# *Iknos*

## 550cc

PrintArea

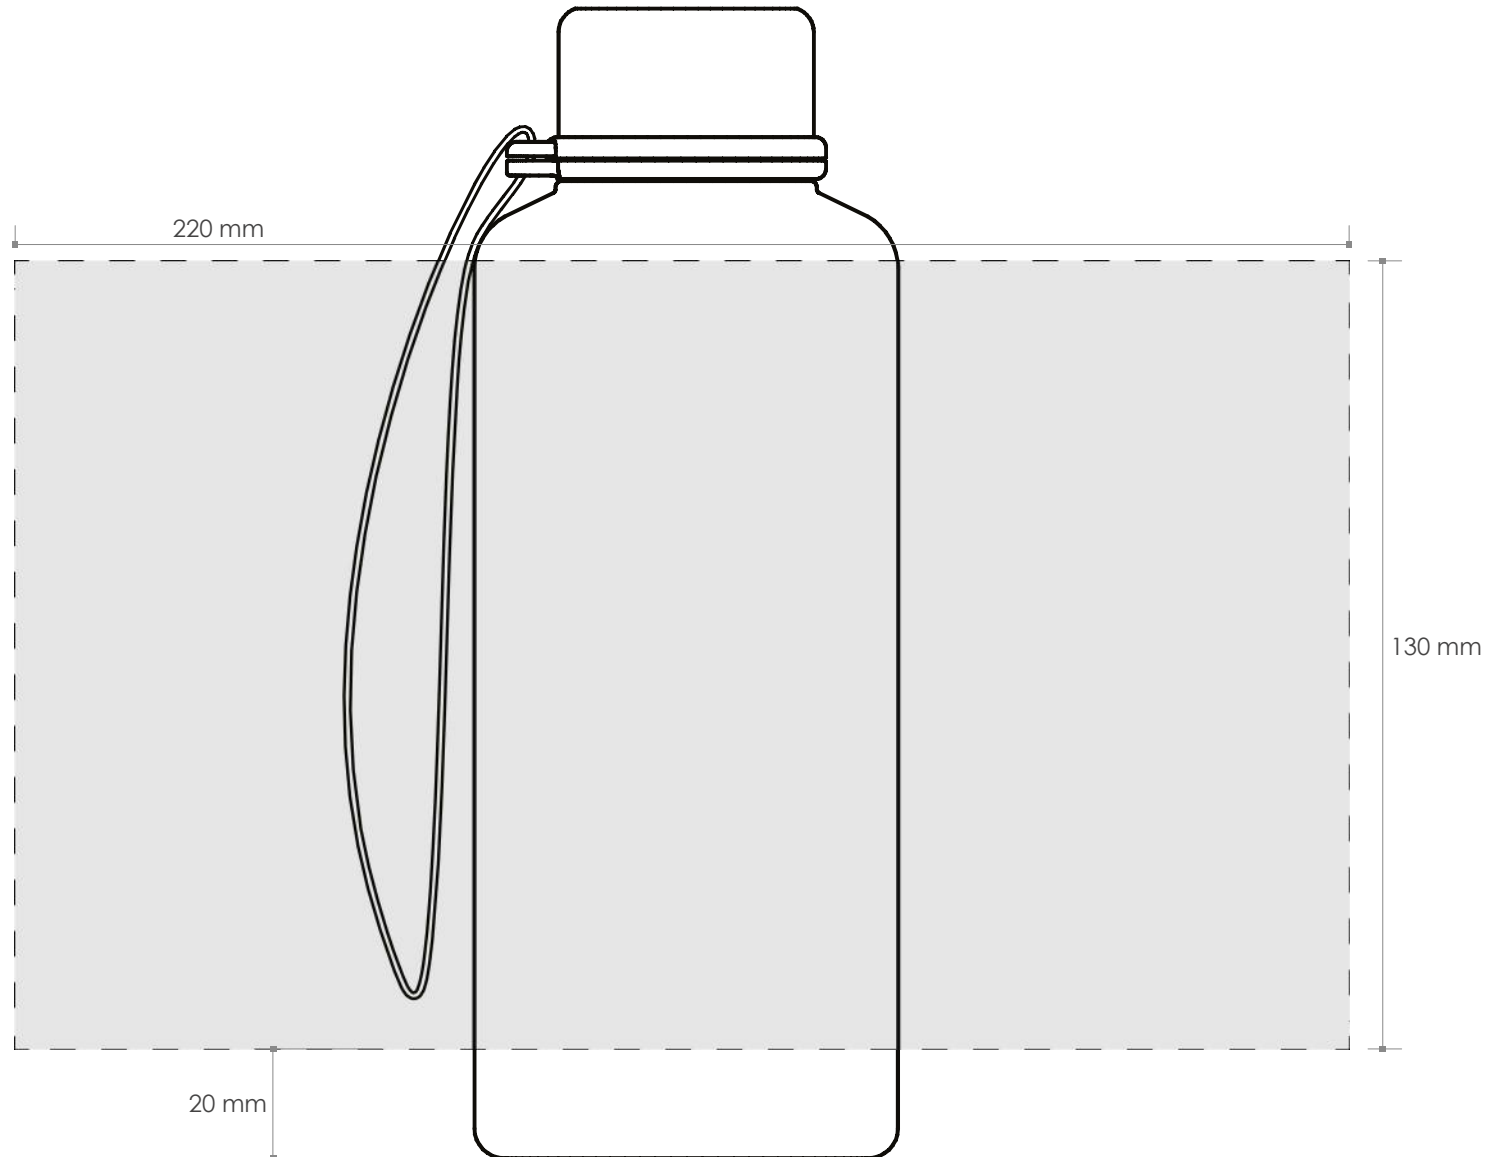
The impression can not close on the circumference of the bottle:  
it's necessary to consider a non-printable area (approx. 0,8 cm width)
